MSC APOLLO 13 INVESTIGATION TEAM

FINAL REPORT

RELATED SYSTEMS EVALUATION

VOLUME I
SUMMARY

FIGURE A-1.- FUEL CELL VALVE MODULE SOLENOID VALVE.

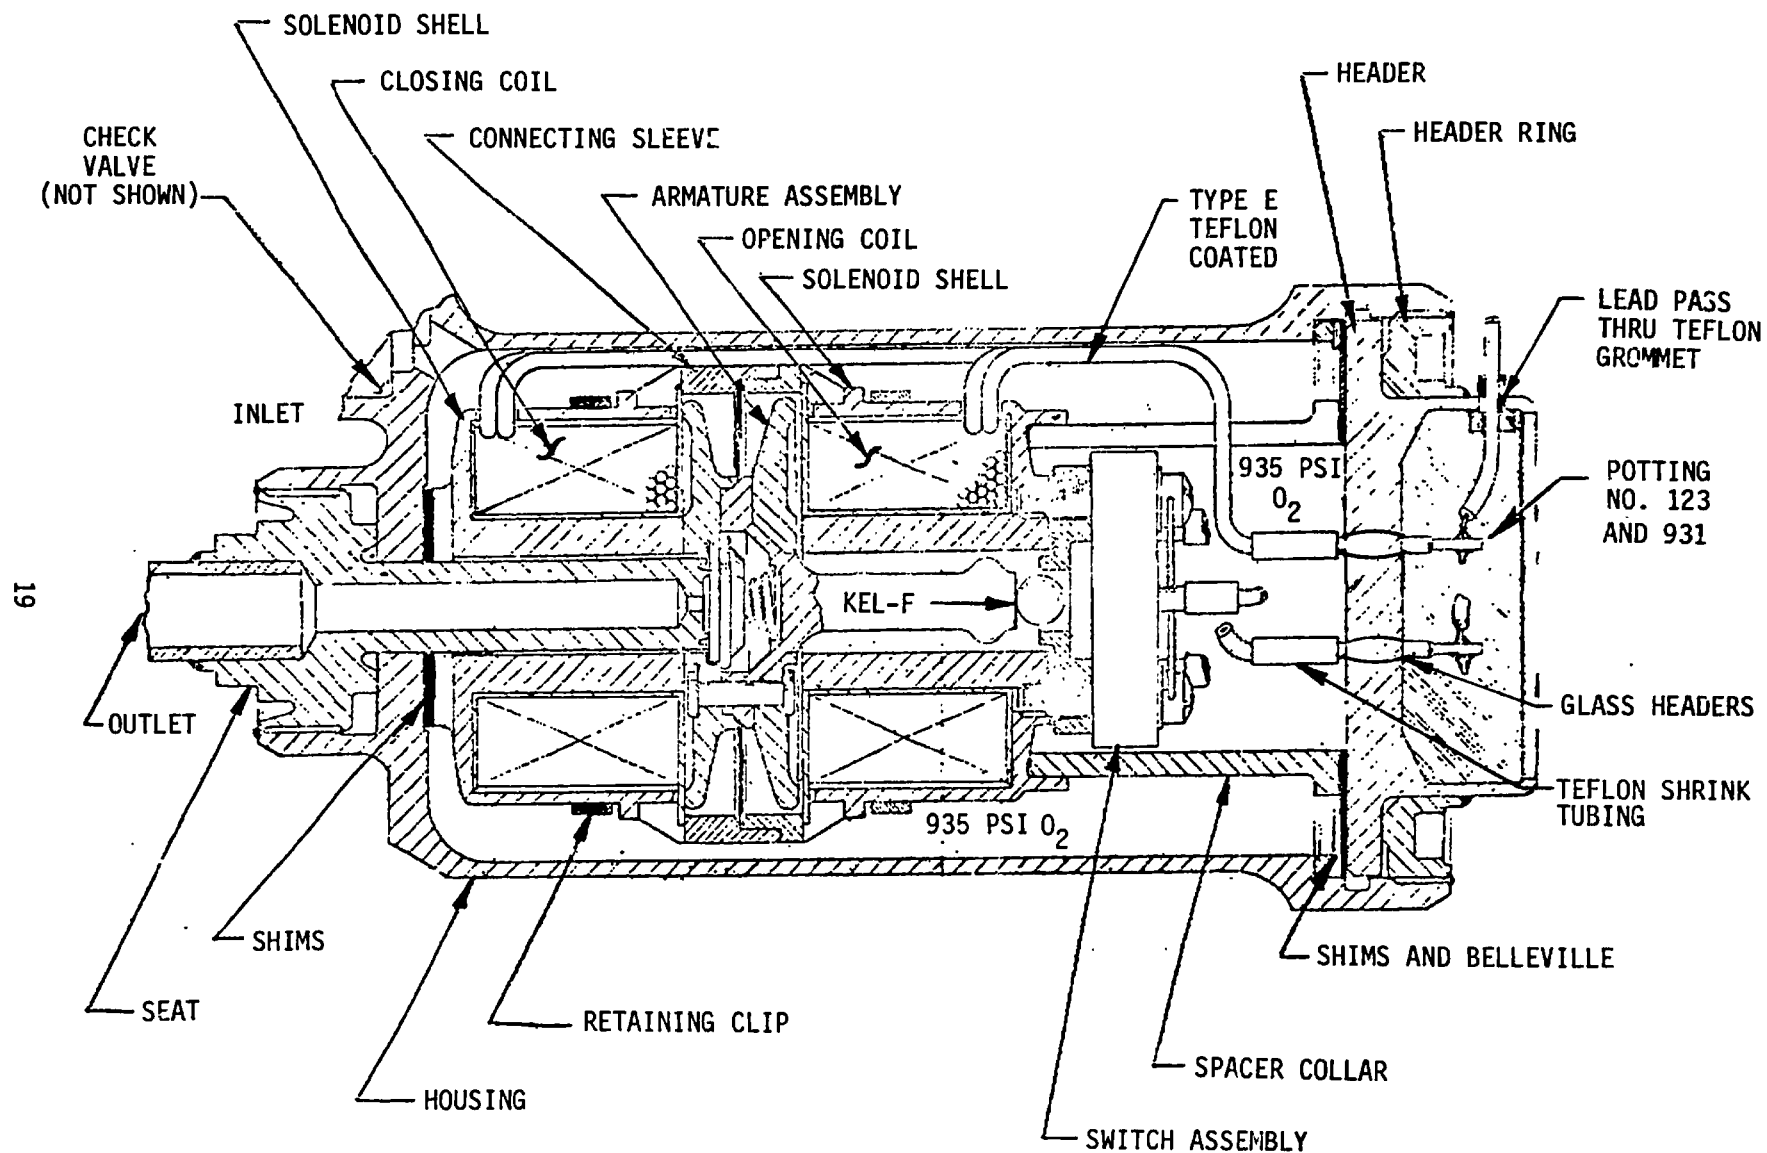
The direct contact between high pressure gaseous oxygen (935 psi) and Teflon-covered power wiring which cannot be inspected after final assembly, such as in the fuel cell oxygen shut off solenoid, is considered an unacceptable design.

Complete the redesign of the fuel cell oxygen shutoff valve (or system) already initiated.

FIGURE A-3.- CM POTABLE AND WASTE WATER QUANTITY TRANSDUCER.

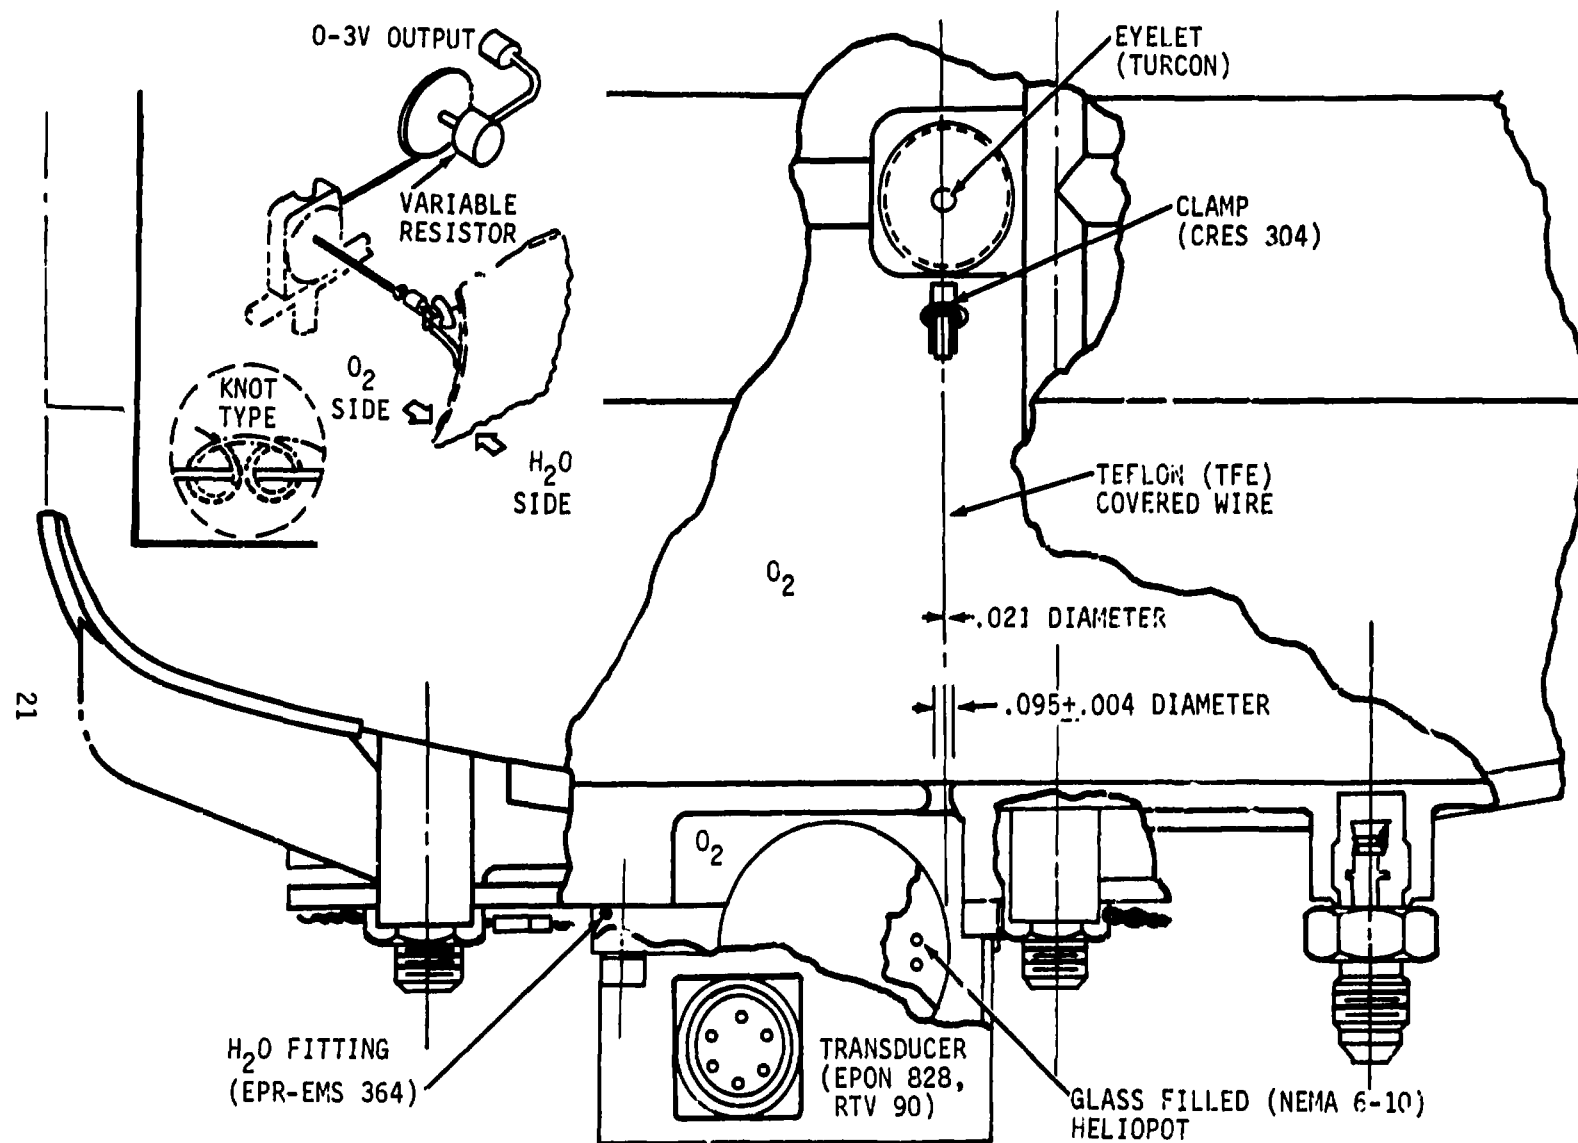
The quantity gaging system (including the electronics) in the potable water and waste water tanks is exposed to oxygen at pressures of 25 psia during flight and 35 psia during countdown. The electronics is supplied by 28 Vdc through two 5 amp circuit breakers. The acceptability of this design will require additional ignition tests which have already been initiated.

Perform analyses of the water quantity gaging system to determine the integrity of the transducer cover and the non-propagation of flame to the bladder for a worst case short in the transducer. If the results indicate a marginal factor of safety, perform a test using actual hardware for both flight and ground conditions. At the same time, the requirement for a water quantity gaging system should be re-examined to determine if it is mandatory for flight.

FIGURE A-6.- SPS OXIDIZER GAUGING SYSTEM

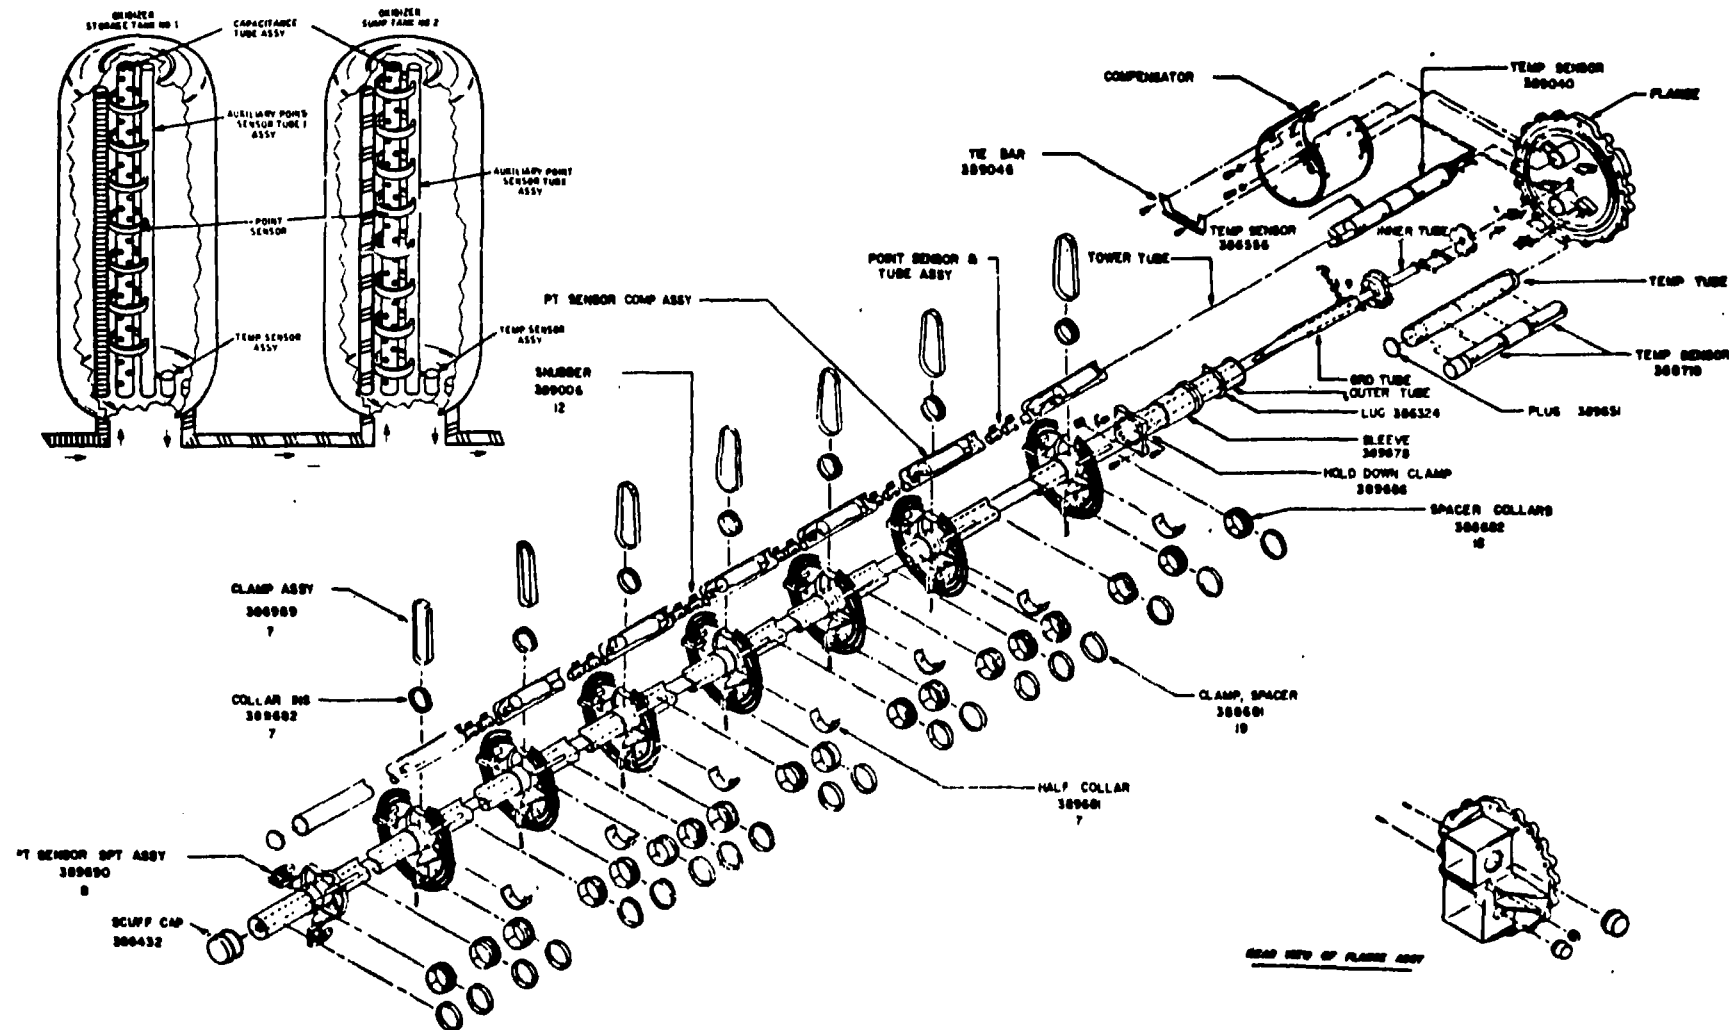
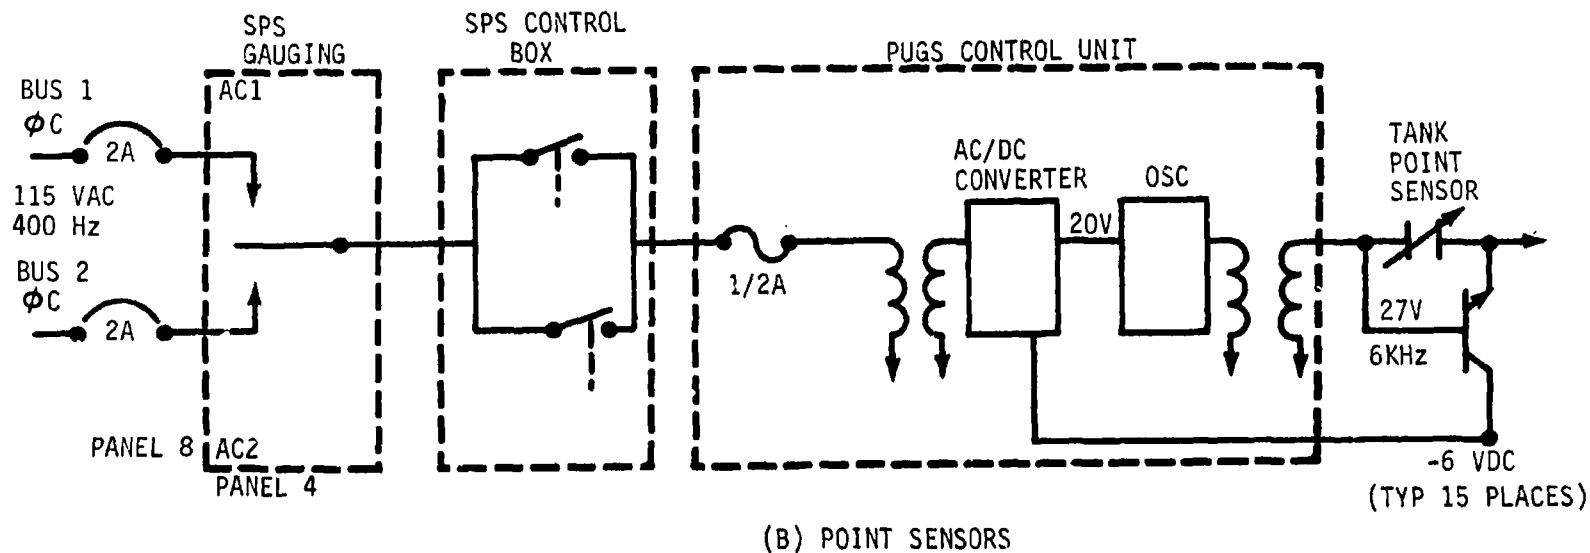
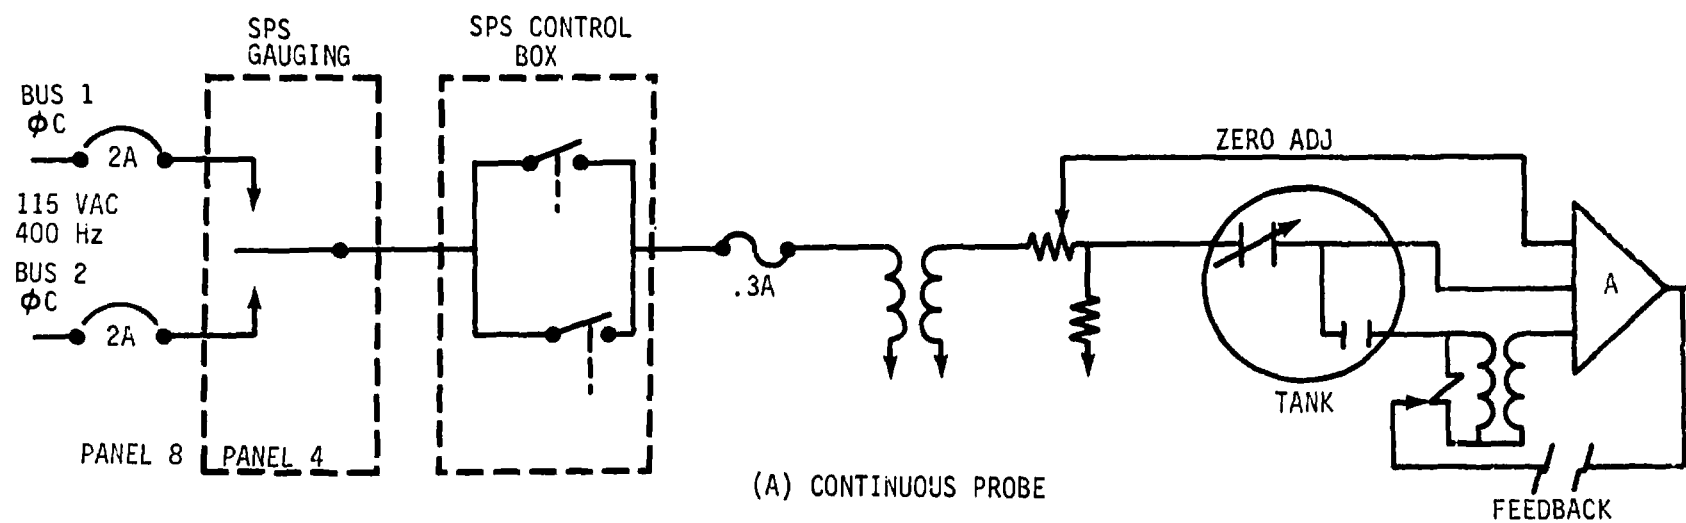
It was not possible to establish the acceptability or unacceptability of the direct contact of electrical components and Teflon with oxidizer and fuel which exists in the SPS quantity gaging sensors. Analysis indicates there should be no problem. Test have been initiated to confirm this analysis.

Complete the testing already initiated to determine whether sustained reactions can be initiated in the SPS quantity gaging sensors within the energy limits of each application.

FIGURE A-7.- PQGS SENSOR.

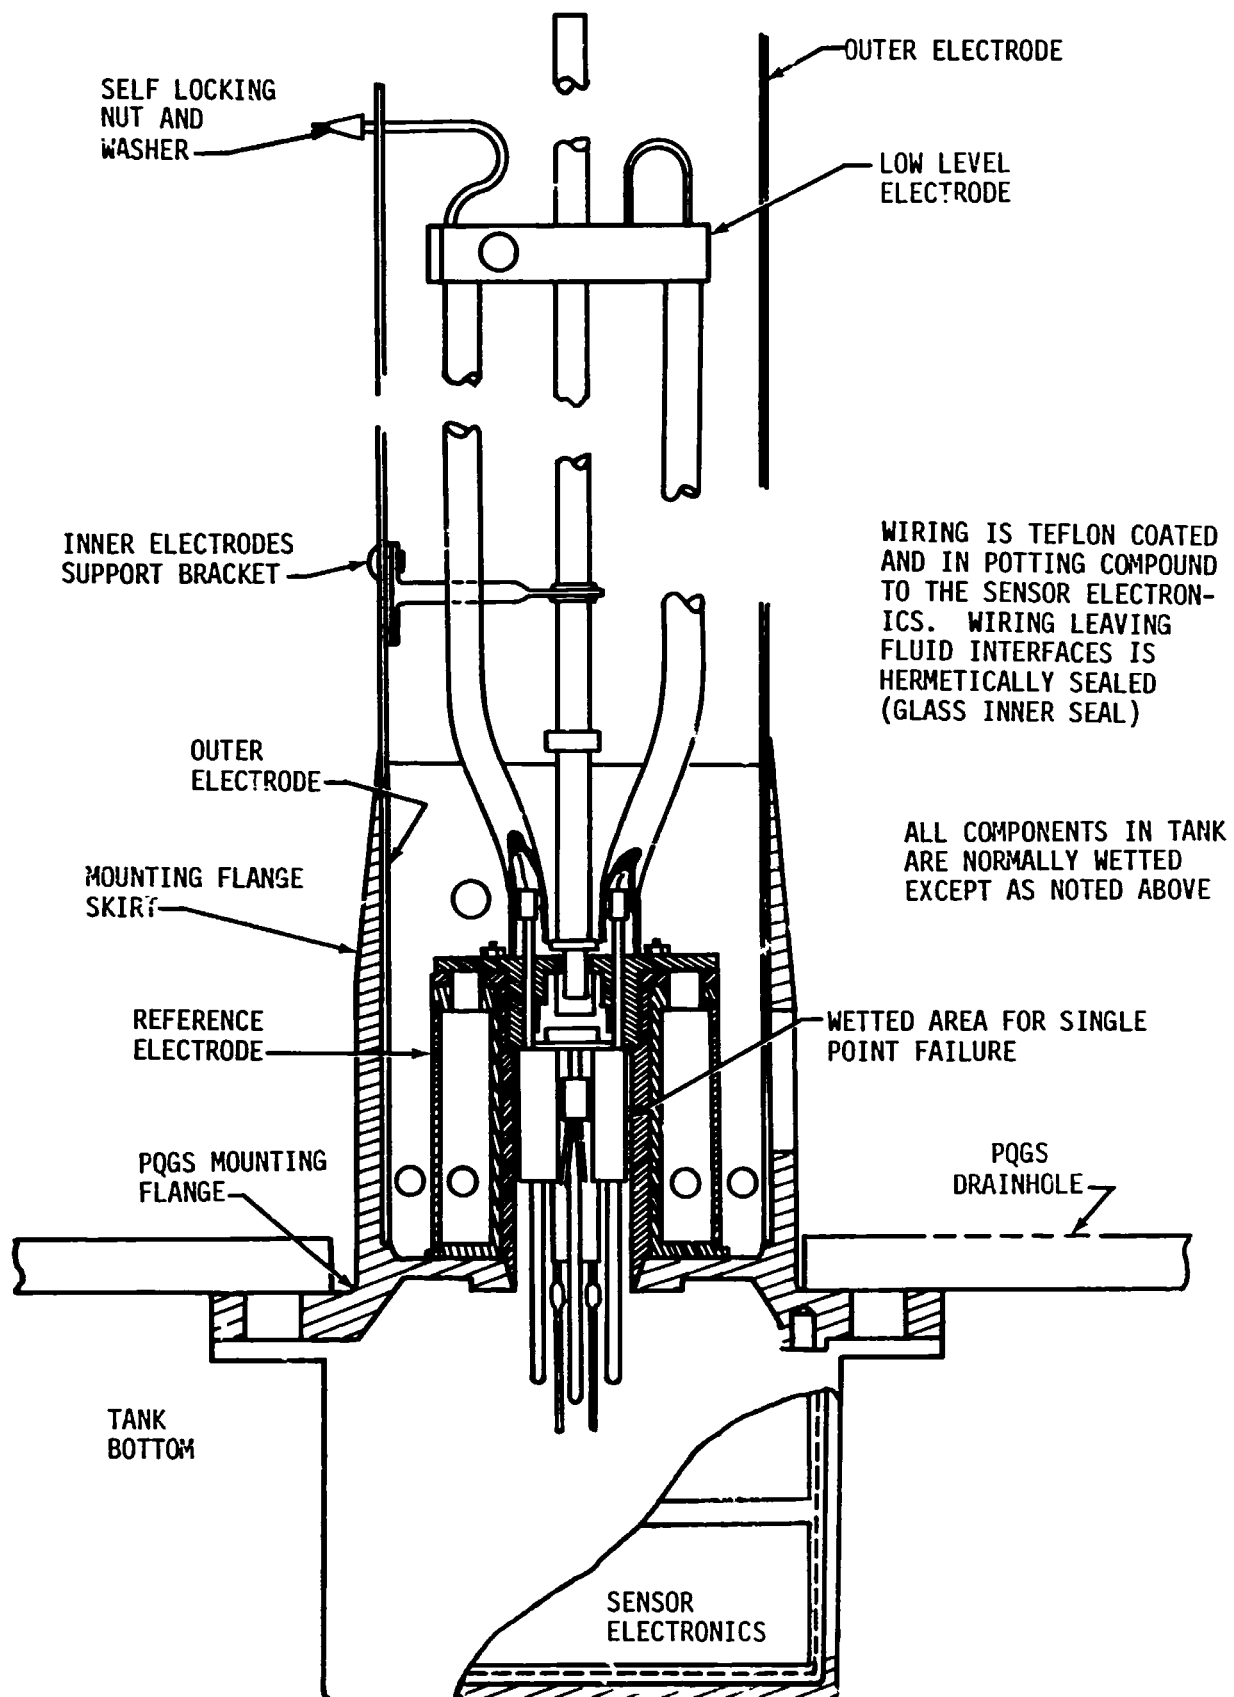
a. None of the electrical components investigated constitute ignition sources in their normal operating modes. Only the PQGS normally exposes electrical devices directly to the pressurized fluid. After thorough analysis it is concluded that adequate circuit protection is provided to preclude ignition.
